Technical Service Information

DAIMLER/CHRYSLER 40TE, 41TE, 42LE, 42RLE, 45RFE & 545RFE NEW BONDED PISTONS

Figure 1

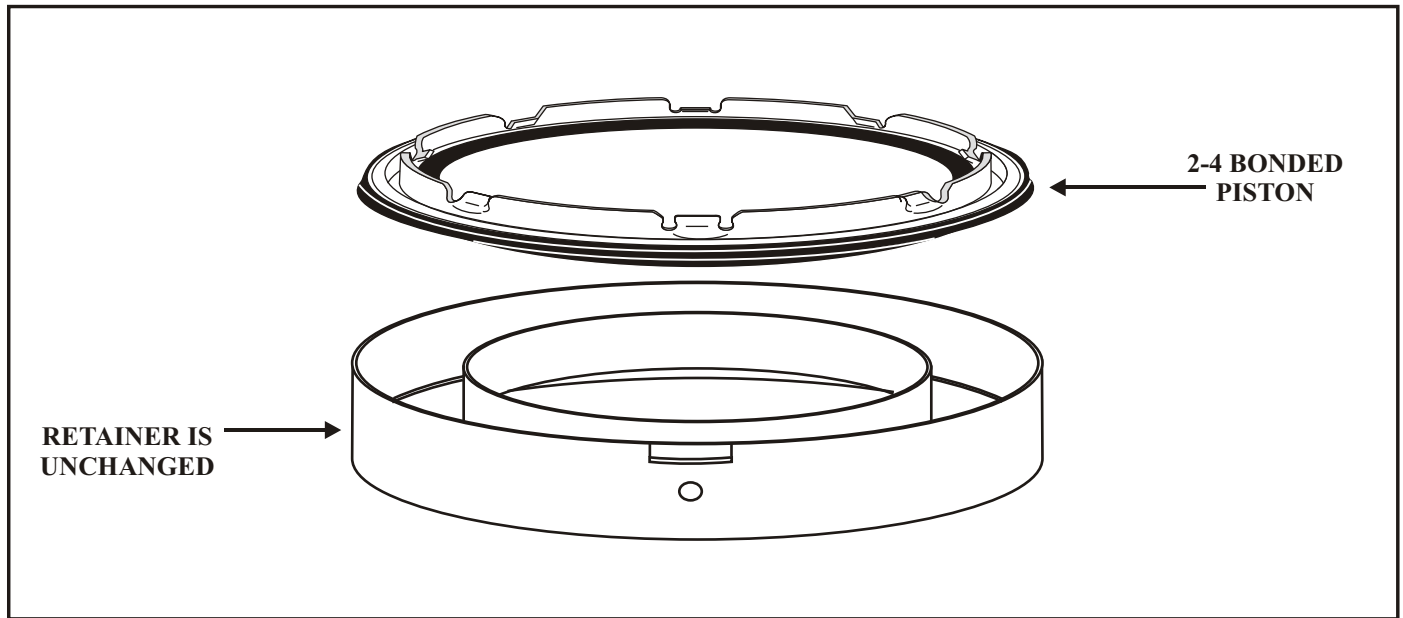
- (1) The 2-4 piston has gone from aluminum, requiring individual lip seals to bonded molded rubber, (Refer to Figure 1). The 2-4 piston comes with the 2-4 retainer, but the retainer is unchanged.
- (2) The Low/Reverse piston has changed from the aluminum type requiring individual lip seals to the bonded molded rubber type, (Refer to Figure 2). NOTE: The Low Reverse piston retainer has the orifice screen installed into it, as it was eliminated from the piston, and must be used with the new bonded piston.
- (3) The Low/Reverse, 2-4, Underdrive and Overdrive accumulator pistons have changed from the aluminum and plastic type requiring individual seals to the bonded molded rubber type, (Refer to Figure 3).
- (4) The low/reverse accumulator cover has also changed from the aluminum type requiring and individual o-ring seal to the bonded molded rubber type.
